**o-OP6- MOSS VALE INDOOR AQUATIC CENTRE, Part Lot  
3 DP1108992, Donkin Avenue, Moss Vale**

**Attachment 4: Peer Review from Wollondilly Shire Council**

<b>To:</b>	Michael Carpenter c/- Wingecarribee Shire Council	<b>From:</b>	Daniel Lukic
<b>File:</b>	LUA11/1092	<b>Date:</b>	22 March 2012
<b>Subject:</b>	PEER REVIEW OF THE MOSS VALE INDOOR AQUATIC CENTRE

**A01-B LANDSCAPE PLAN**

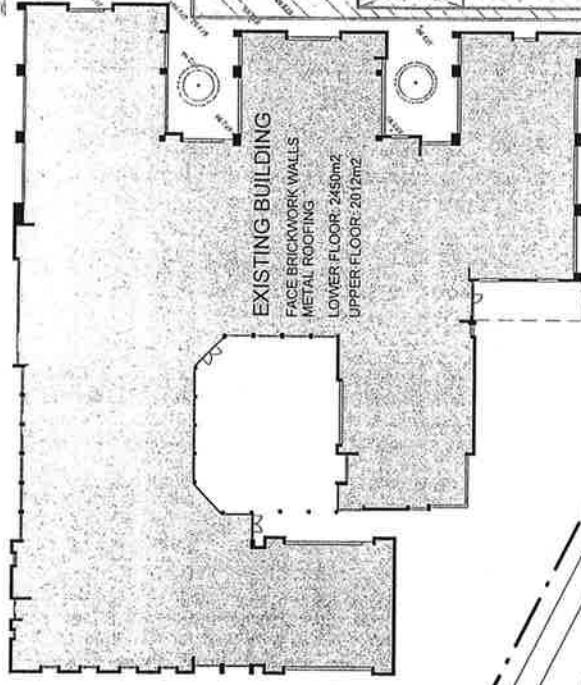
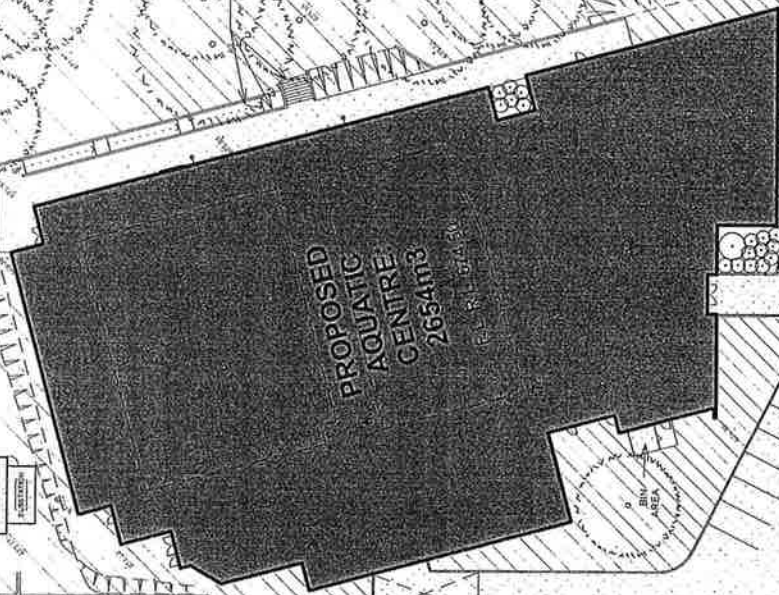
The site plan shows a freestanding pole sign that would be located at the front of the development. The Statement of Environmental Effects provides no assessment with regard to the provisions of the plan.

Comments: an indicative plan has been submitted with the application. It is recommended that some landscaping be established along the Kirkham Street frontage to help soften the development and provide a decorative separation between the pedestrian and parking areas,

Comments: concerns are raised with the number of parking spaces that would be used to accommodate all uses proposed as part of this development. A total of forty (40) spaces have been shown on the plan and this is considered to represents a significant shortfall.

It would be appropriate to include a condition in the consent to require the submission of a new Development Application for assessment and determination in relation to signage (other than signage that is exempt development).

If the application were to be approved, it is recommended that the additional sixty (60) parking spaces (a total of 100 spaces overall) be constructed and ready upon the commencement of use of the aquatic centre.

### A02 FLOOR PLAN

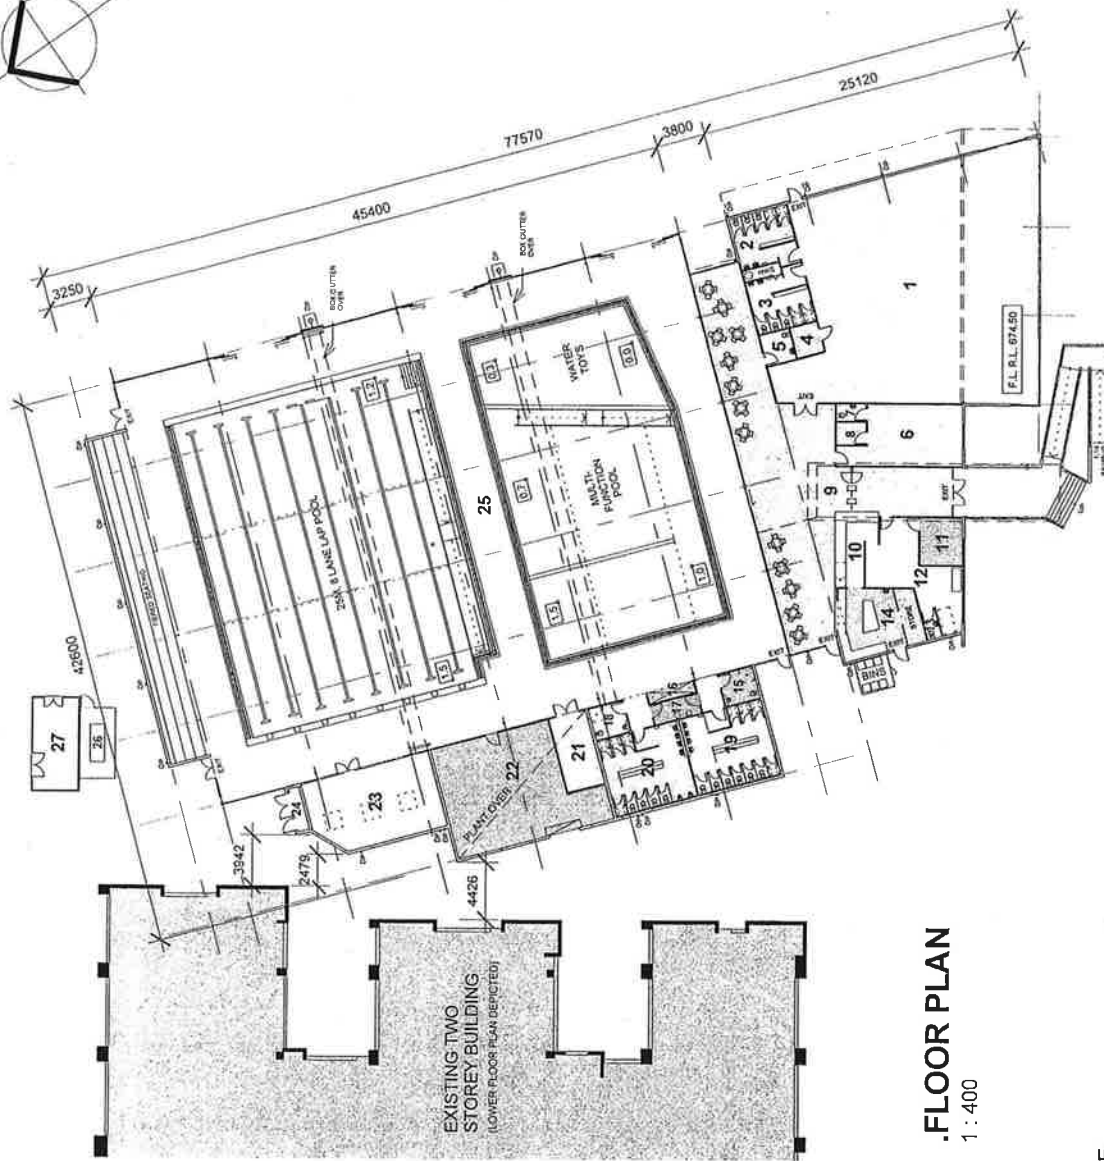
It is recommended that the design of the pool be altered to provide disabled access to both swimming pools. An option that should be given consideration is joining the pools together to facilitate compliance with the Commonwealth legislation.
